# Preliminary Drainage Report

## **Eagle Rising**

**Project No. 61145**

Also see comment  
memo

HEC-RAS Water Surface Elevations Calculations

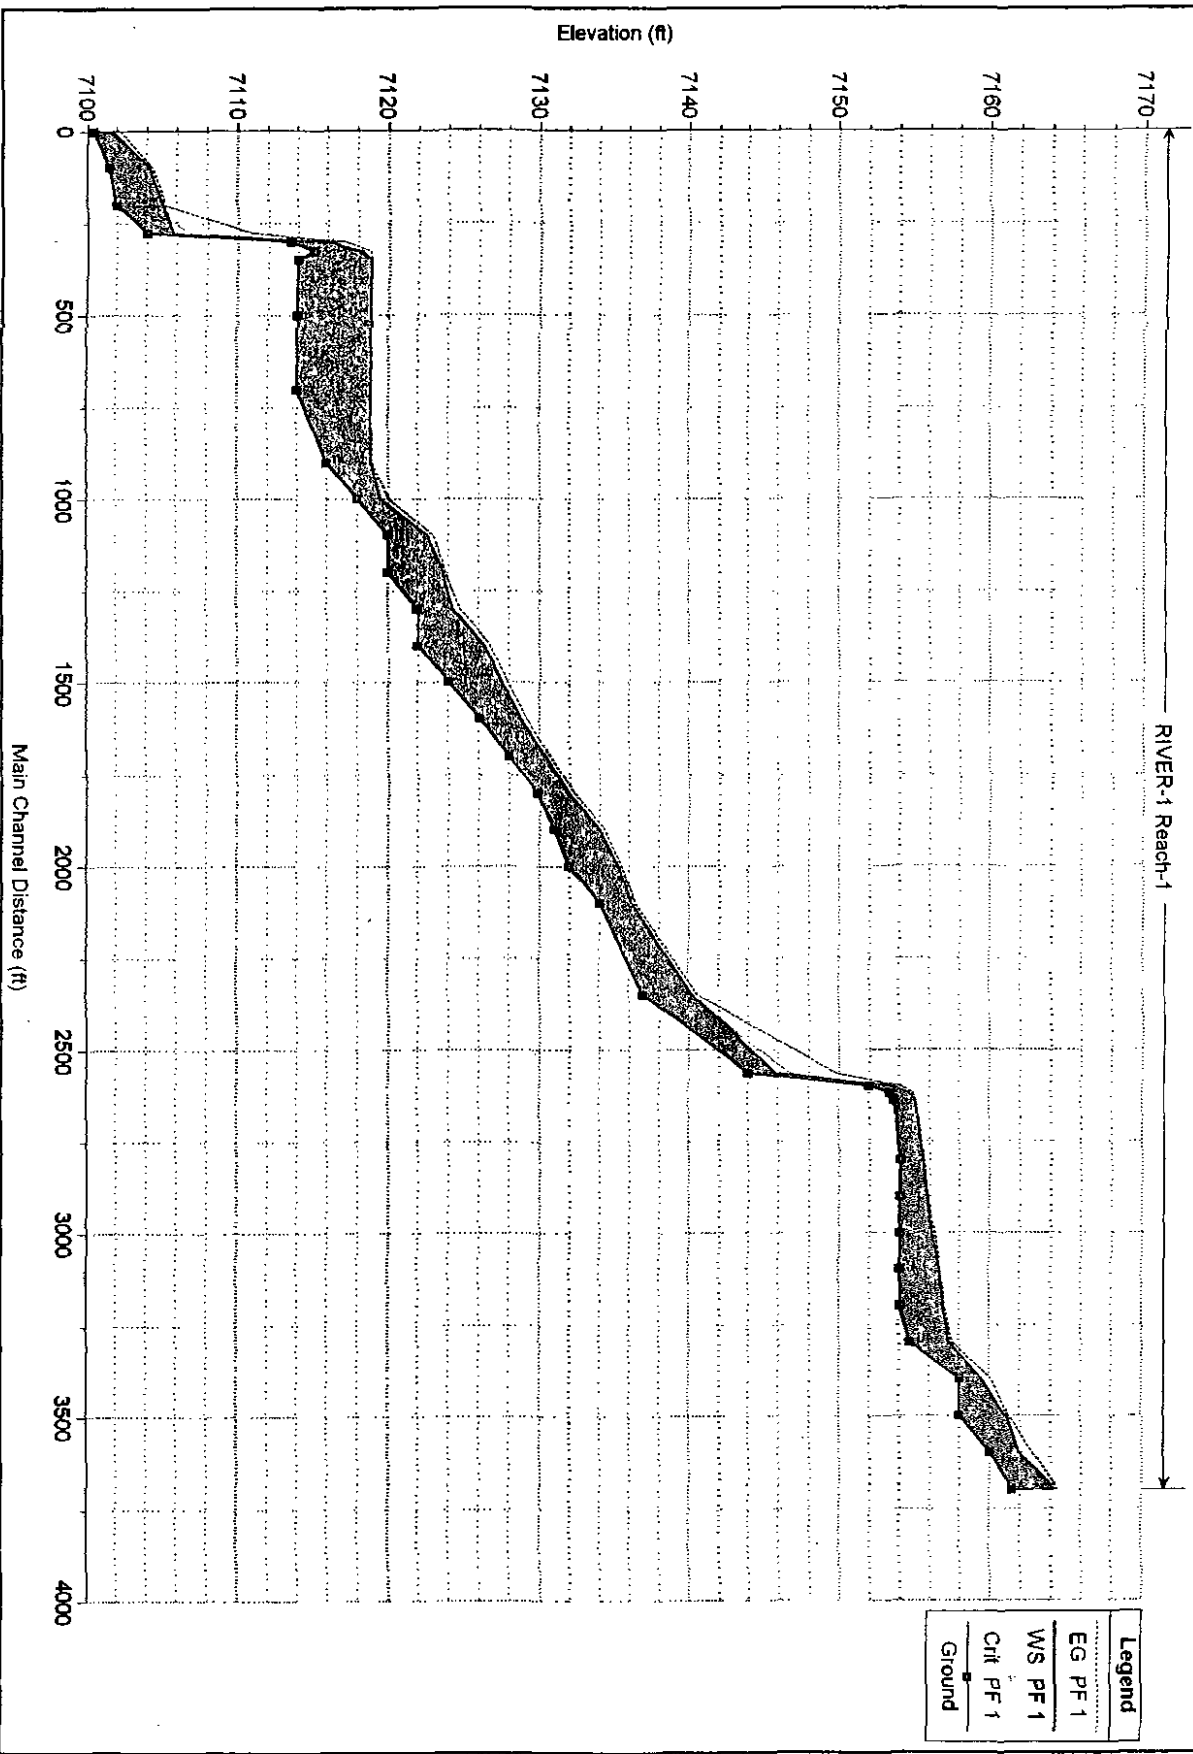
not found?

**PRELIMINARY PLAN - REINSTATED**  
**EAGLE RISING**  
 CASAS LIMITED PARTNERSHIP #4  
 P.O. BOX 2076, COLORADO SPRINGS, CO 80901-2076

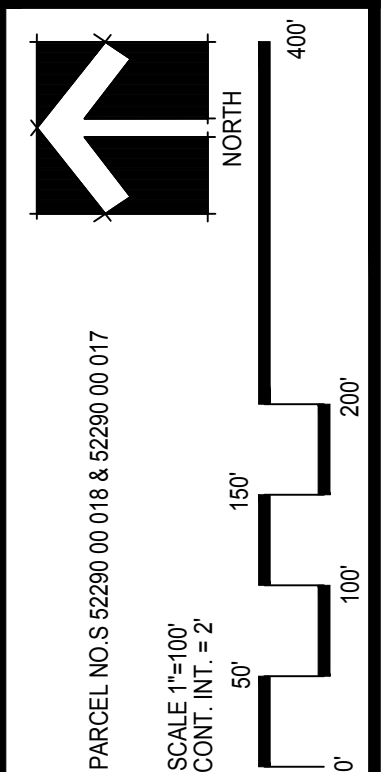
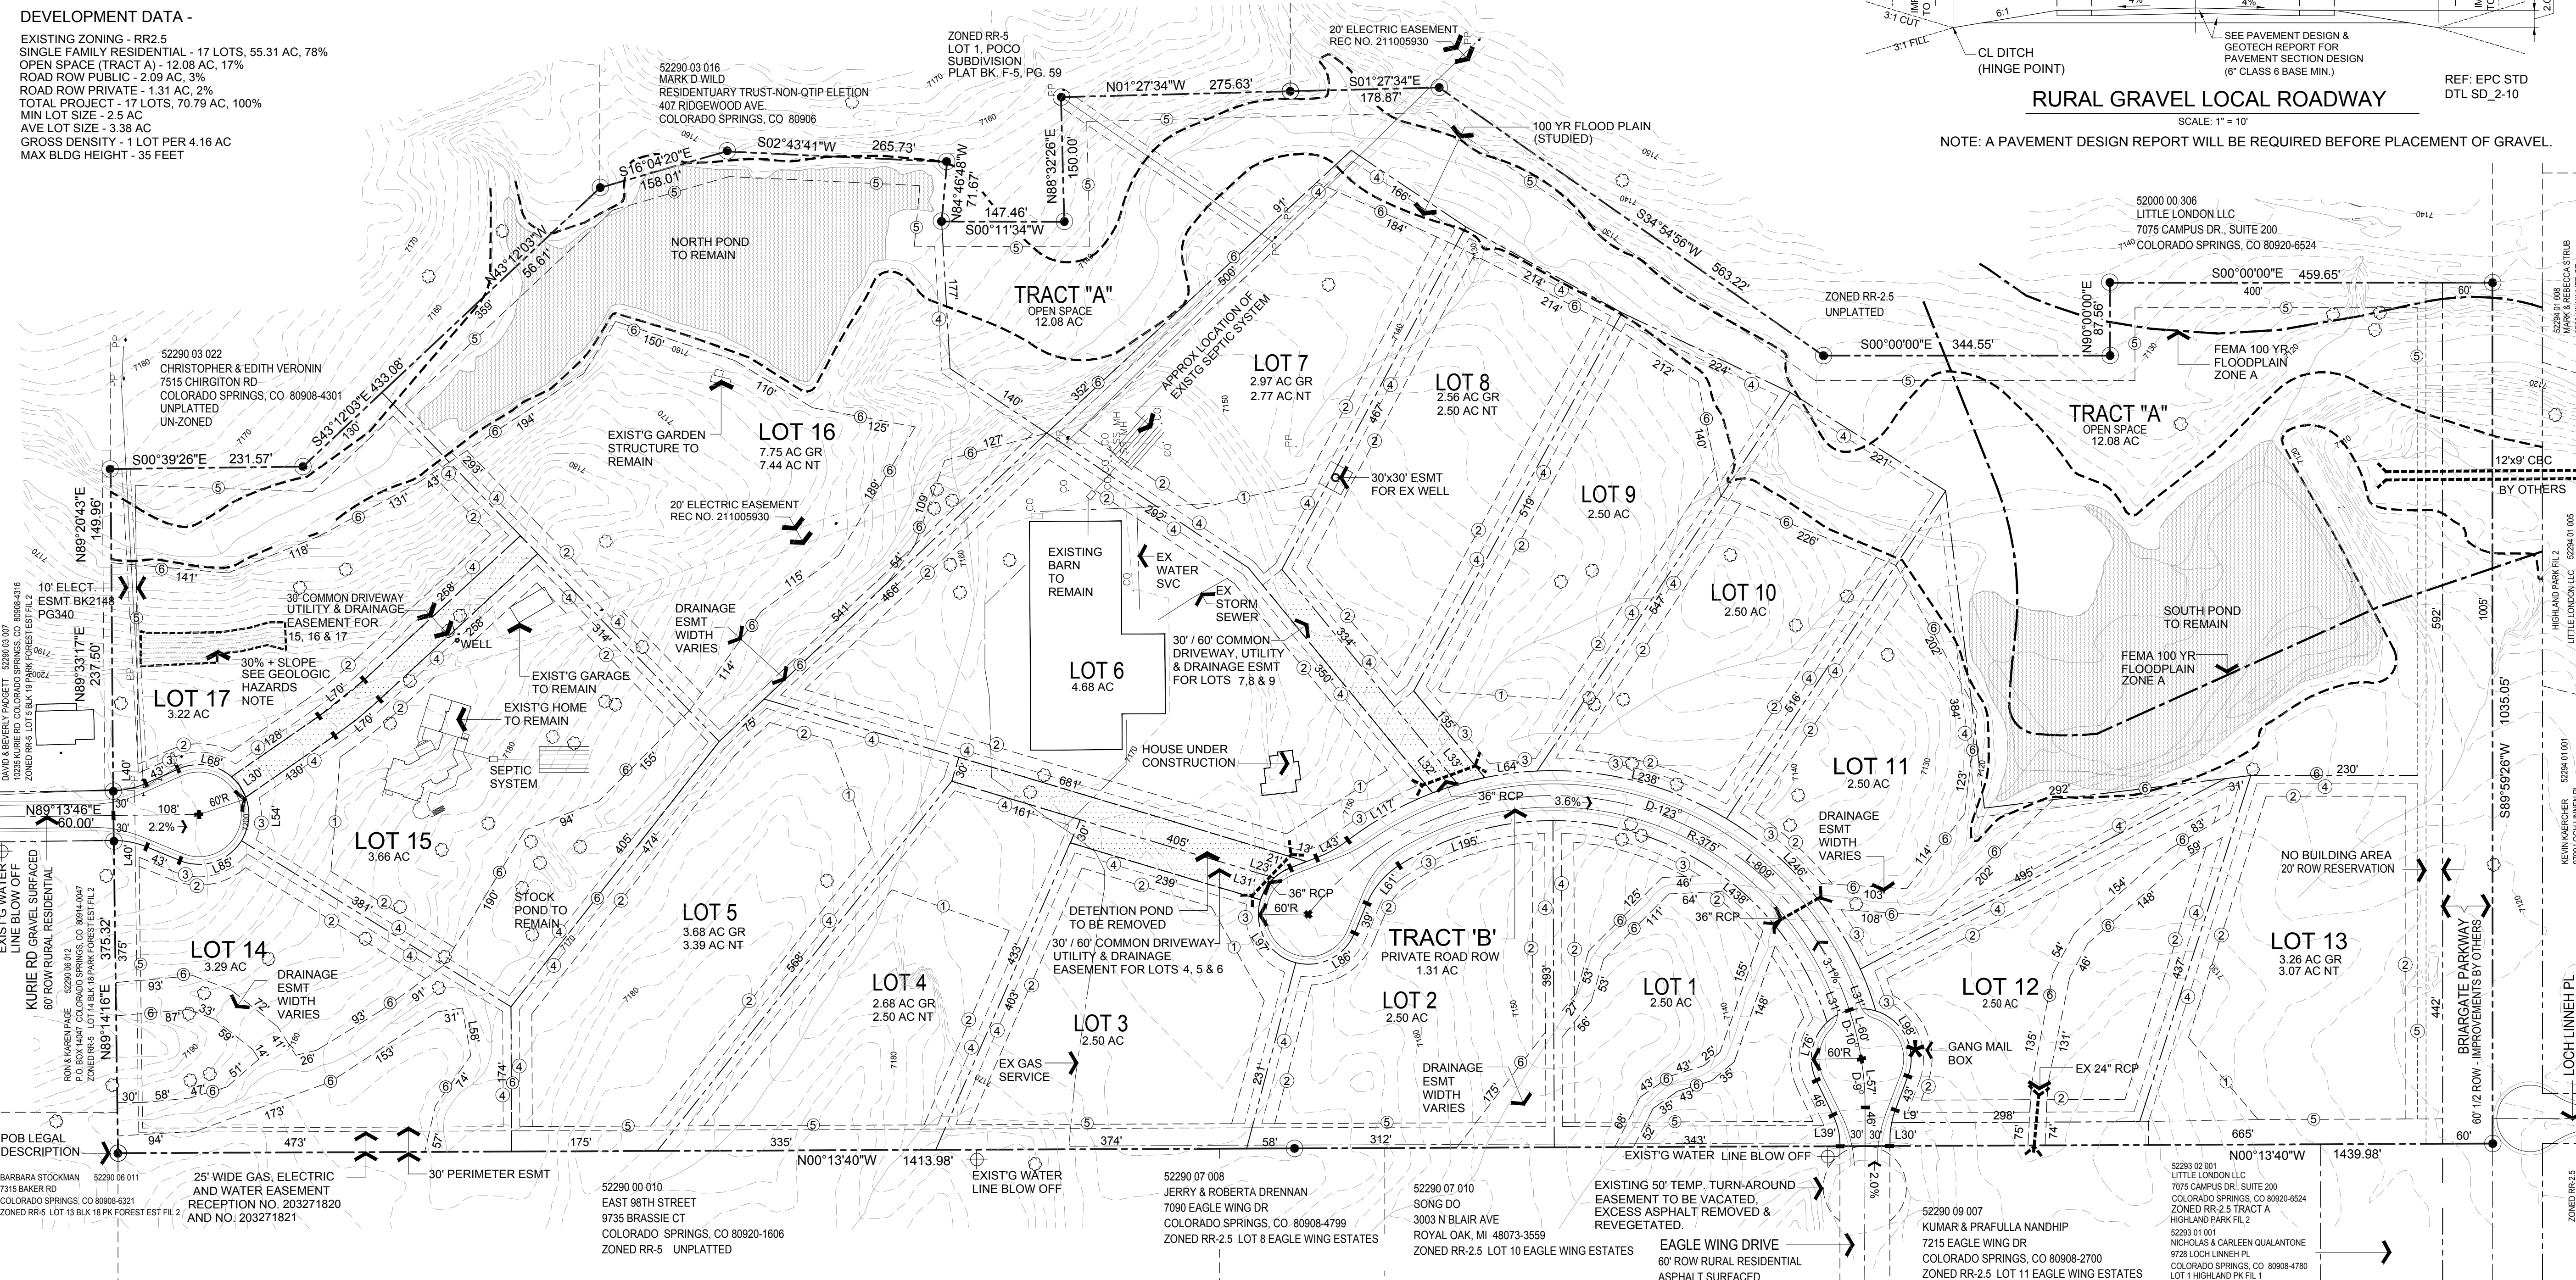
This is not an approved plan
